ITEM FOR ENVIRONMENTAL COMMISSION AGENDA

PROJECT: Country Club Creek Trail- Elmont Dr. to E. Oltorf St. (SP-2022-0197D)

Variance request is as follows:
Request to vary from LDC 25-8-341 to allow cut over 4 feet to 10 feet.

Development Services Department
Staff Recommendations Concerning Required Findings

CITY OF AUSTIN, TEXAS
PUBLIC WORKS DEPARTMENT
ENGINEERING SERVICES DIVISION
COUNTRY CLUB CREEK TRAIL -
ELMONT DR. TO E. OLTORF ST.
PROPOSED CUT/FILL EXHIBIT

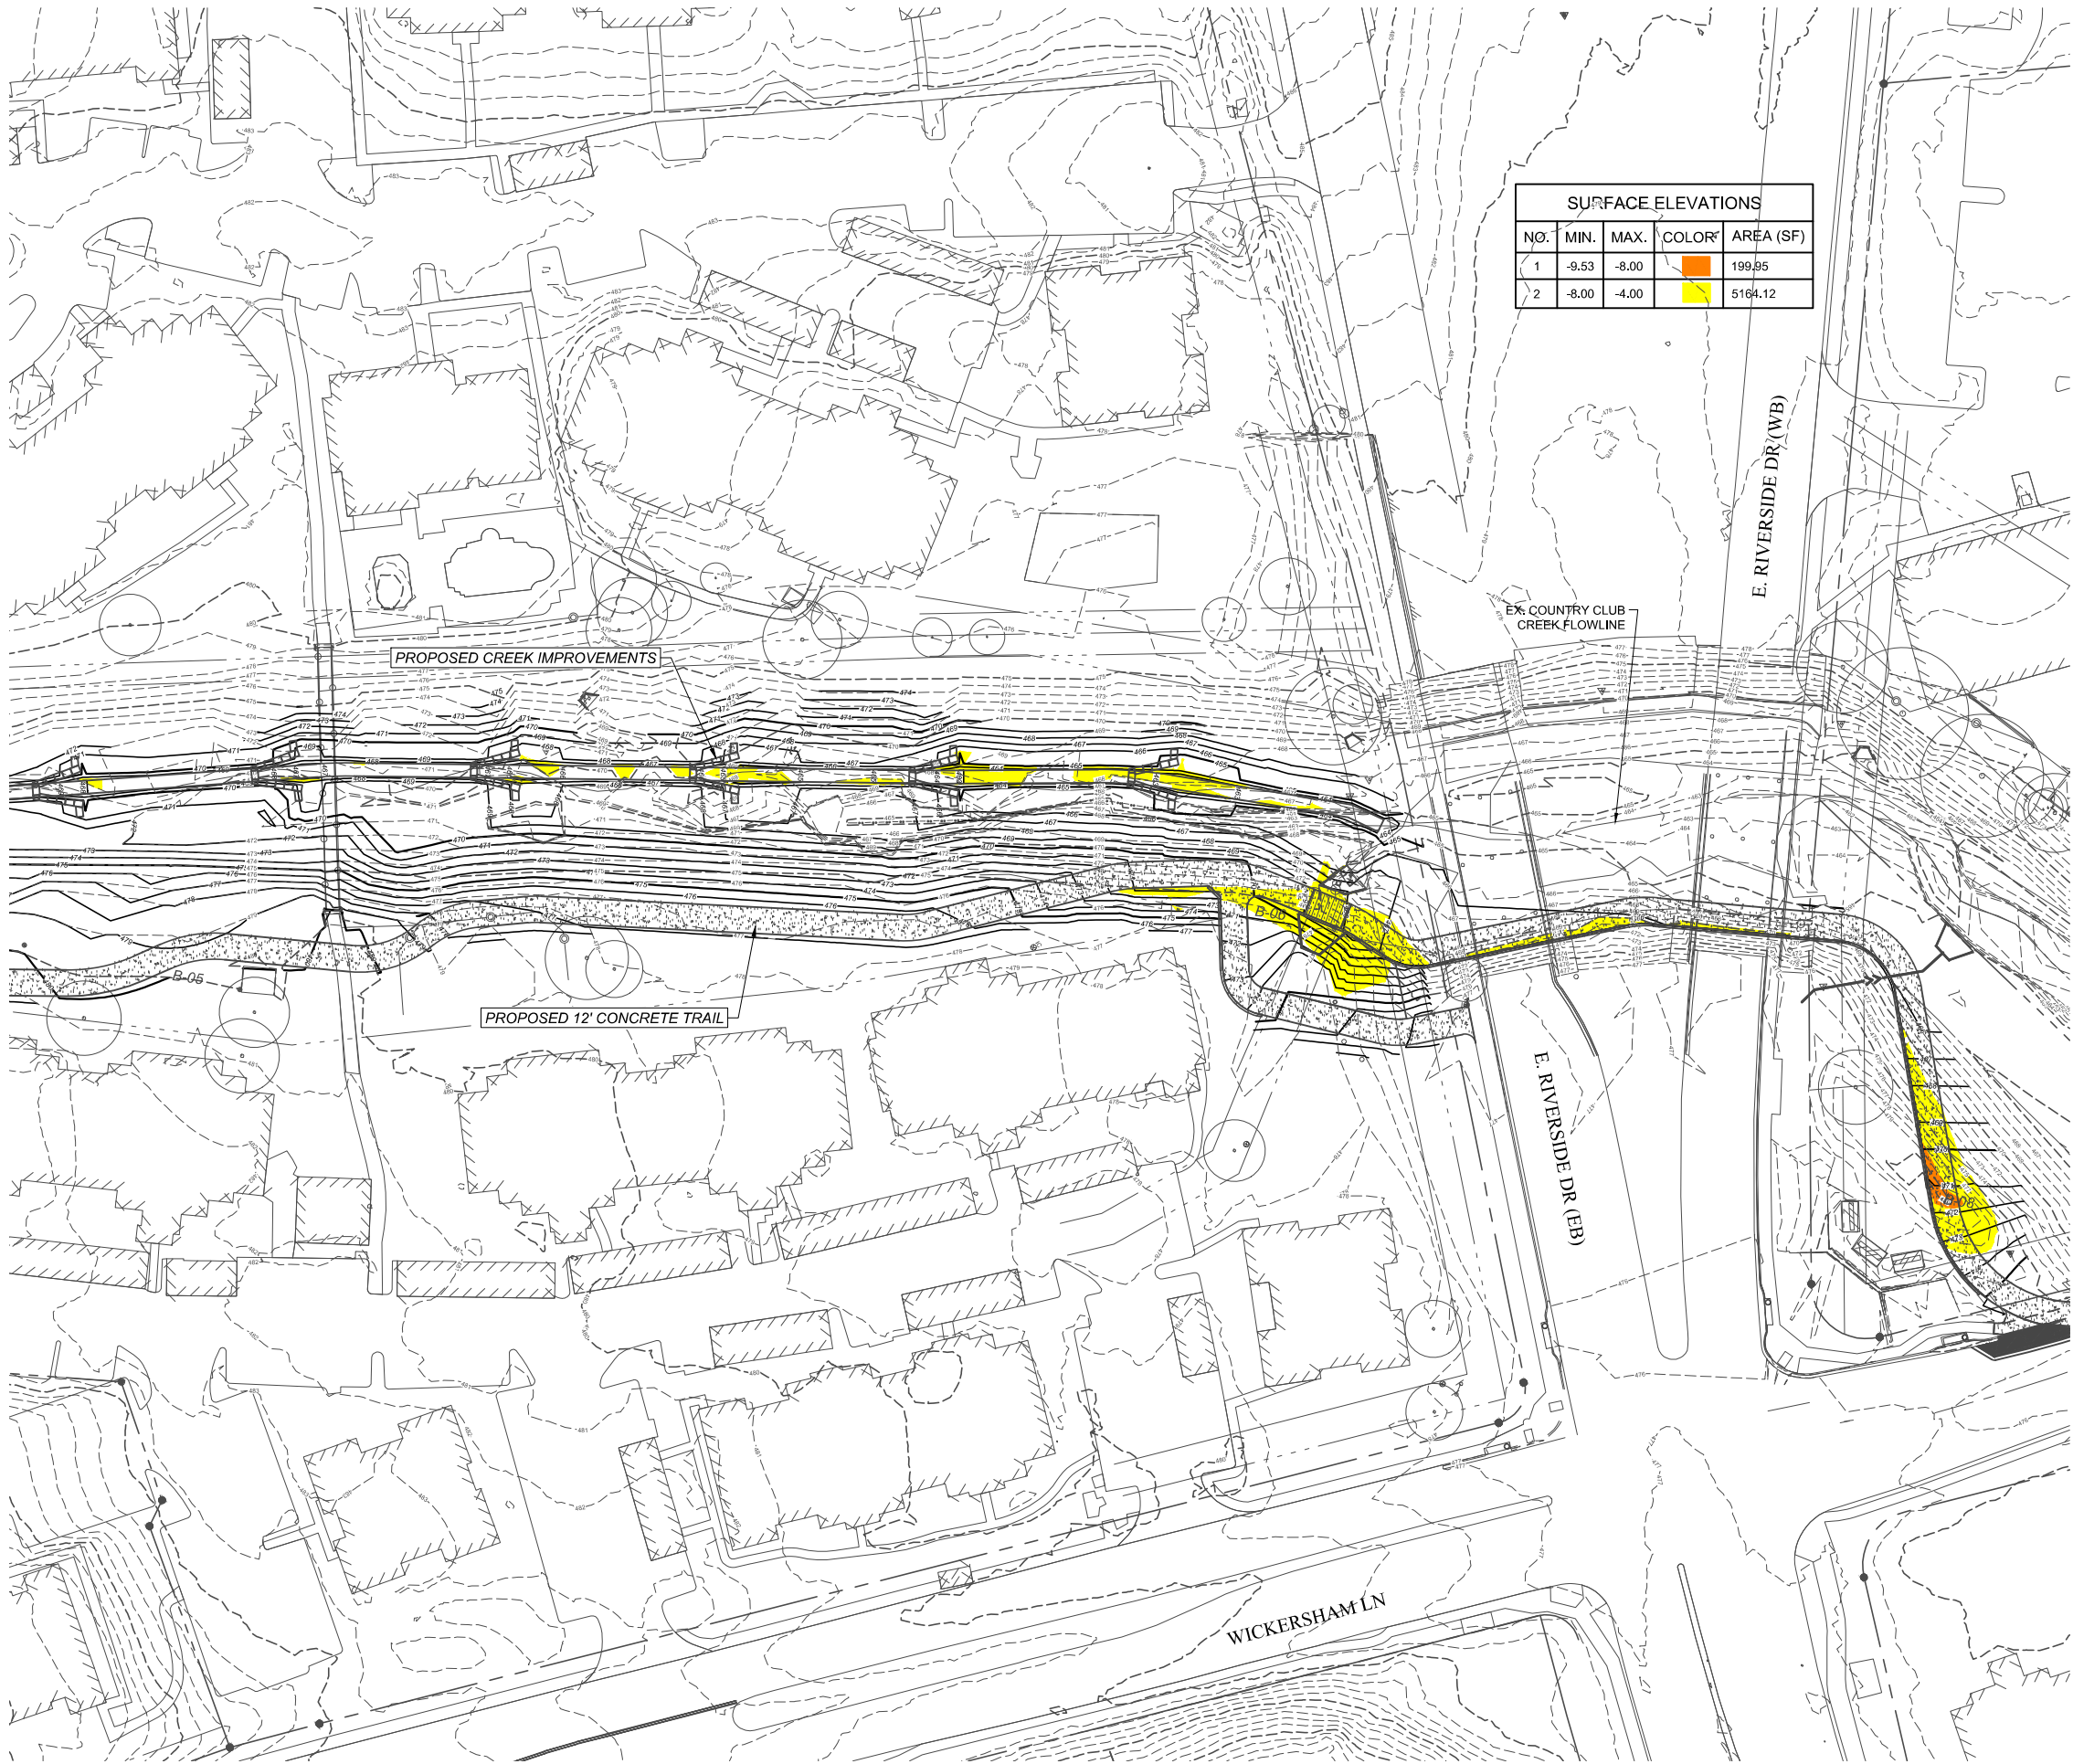
Clearly indicate in what way the proposed project does not comply with current Code (include maps and exhibits)	The proposed project does not comply with LDC 25-8-341 for cut in excess of 4 feet in depth within the Suburban watershed (Desired Development Zone). An administrative variance for cut up to 8 feet in depth is not possible since the areas of cut that exceed 4 feet in depth are located within 100 feet of a classified waterway.
---	---

Provide structural containment of cut with retaining walls.

Provide structural containment of the cut for the multi-use trail with a retaining wall.
